Urgent: Medical Device Correction

Single Chamber Temporary External Pacemaker 53401

All Serial Numbers Distributed February 2017- November 2017

21 June 2018

FIGURE 1- updated firmware displayed in this image

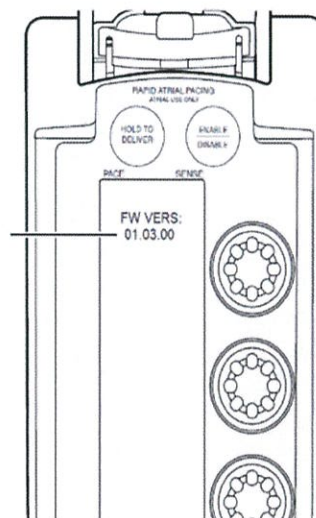
1. Verify whether 53401 EPGs in your possession are affected (See Appendix A: Serial Number List).
2. If your EPG is affected, complete the following:
 - Determine if the EPG firmware has been updated.
 - Power unit on and view firmware version (Figure 1 below).
 - If firmware version is 01.03.00 or greater, EPG firmware has been updated with correction for this issue. Continue to Step 3 to confirm that you were informed of the issue. No other action is recommended.

If firmware version is 01.02.00, EPG firmware has not been updated. You may arrange to have your Medtronic Service Center update the EPG firmware at no charge.
3. Please complete the attached Confirmation Form in its entirety and return it as directed to confirm your receipt and understanding of this information. You must complete this form even if all units in your inventory have the correct firmware version.

During power up process, Firmware Version will be displayed for 2 seconds
